City of Santa Barbara California

PLANNING COMMISSION STAFF REPORT

REPORT DATE: December 12, 2013
AGENDA DATE: December 19, 2013
PROJECT ADDRESS: 520 E. Yanonali St (MST2013-00388)
 El Estero Wastewater Treatment Plant
 Tertiary Filtration Plant Replacement
TO: Planning Commission
FROM: Planning Division, (805) 564-5470, extension 4558
 Renee Brooke, AICP, Senior Planner *RB*
 Steven Greer, Project Planner/Environmental Analyst

EEMWTP TERTIARY FILTRATION PLANT REPLACEMENT
 M/F/F FACILITY
 ROOF PLAN

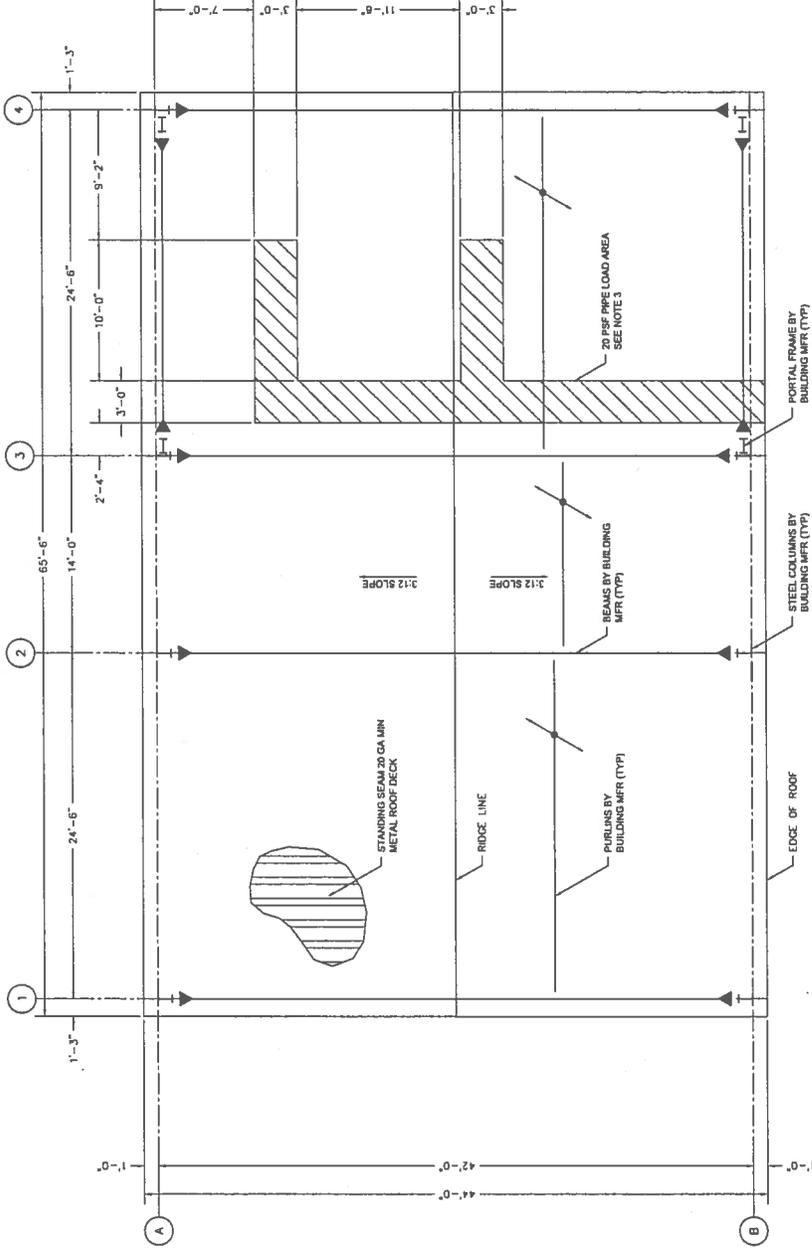
- 4) Study longer roof eave overhangs to provide weather and solar protection and to add more architectural character to the building.
- 5) The Board requested to know if a full sound analysis is required by staff under additional CEQA review, and if any modifications will be required to comply.

- 6) Study to adapt the building to provide future solar panels to the building.
- 7) At least two Board members prefer that the project be restudied and redesigned to be enclosed in a building.

The applicant has revised the design of the canopy structure to include extended eaves for weather protection and architectural enhancement as recommended. The canopy structural design has also been modified to allow for future installation of solar panels.

- NOTES:
- 1 MINIMUM COLLATERAL LOAD ON ROOF: 10 PSF. FUTURE COLLATERAL LOADS SHALL BE CONSIDERED CONCURRENTLY WITH ROOF LIVE LOAD.
 - 2 FUTURE SOLAR PANEL LOAD SHALL BE 5 PSF ON ENTIRE ROOF SURFACE.
 - 3 LOAD IN PLACE OF 10 PSF COLLATERAL LOAD.
 - 4 BUILDING MANUFACTURER TO PROVIDE REQUIRED ROOF SUPPORT FOR PROCESS MECHANICAL PIPING.
